# SERVICE BULLETIN

**PRODUCT: COMPUTER MONITOR**  
**BULLETIN: MONITOR 95-008**  
**MODEL: SAMTRON SC-428PT/L**

**SUBJECT:** No Raster

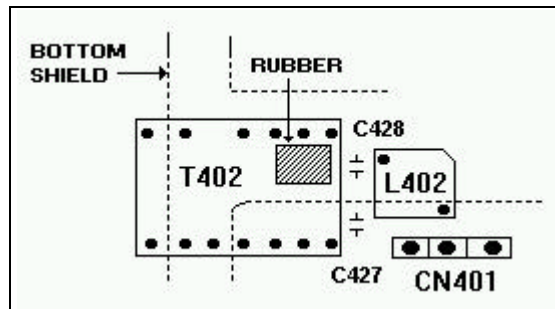
**BACKGROUND:** A whistling sound is created from harmonic noise generated between T402, L402, and the main PCB near the Flyback Transformer.

**SOLUTION:** Add a piece of rubber to insulate the main PCB solder side from the bottom metal shield. See Illustration below showing the section of the PCB where the rubber will be located.

**Figure 1**

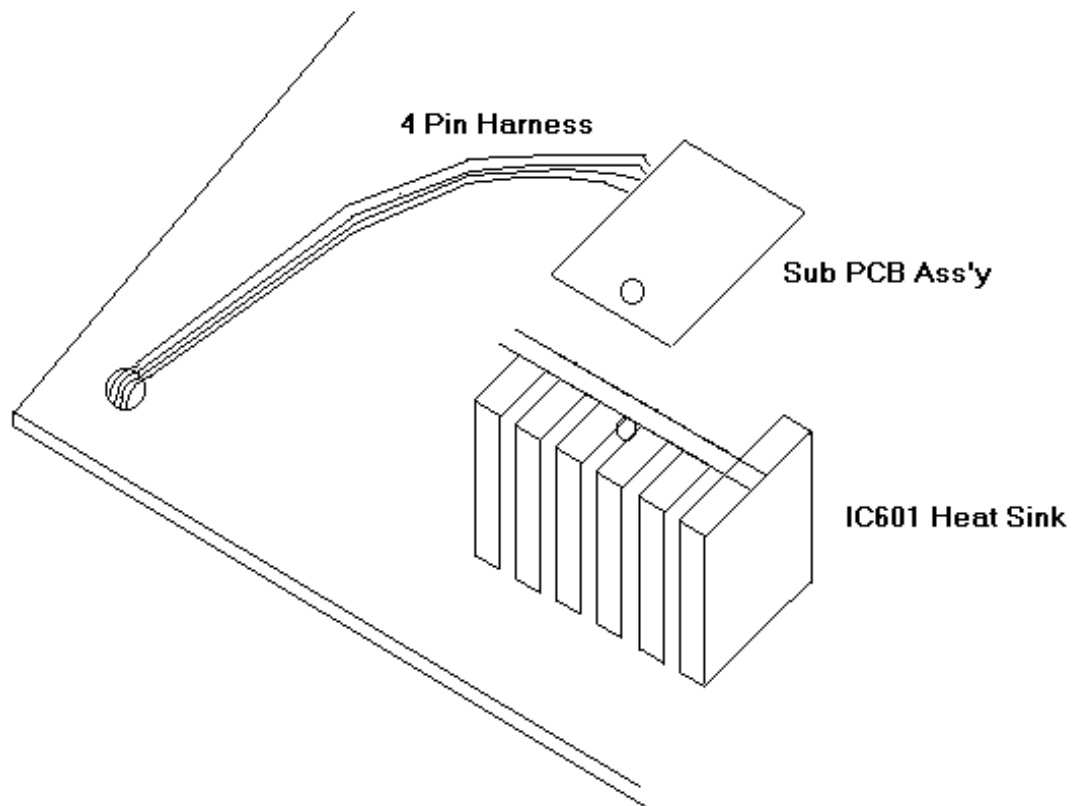
**BACKGROUND:** Q407 fails due to a transient pulse and current when mode switching from DOS to Windows. This occurs with a Matrox video card installed in the computer.

**SOLUTION:** Add a sub-PCB assembly as in figures 1 and 2 and a snubbing circuit for the horizontal output as in figure 3.
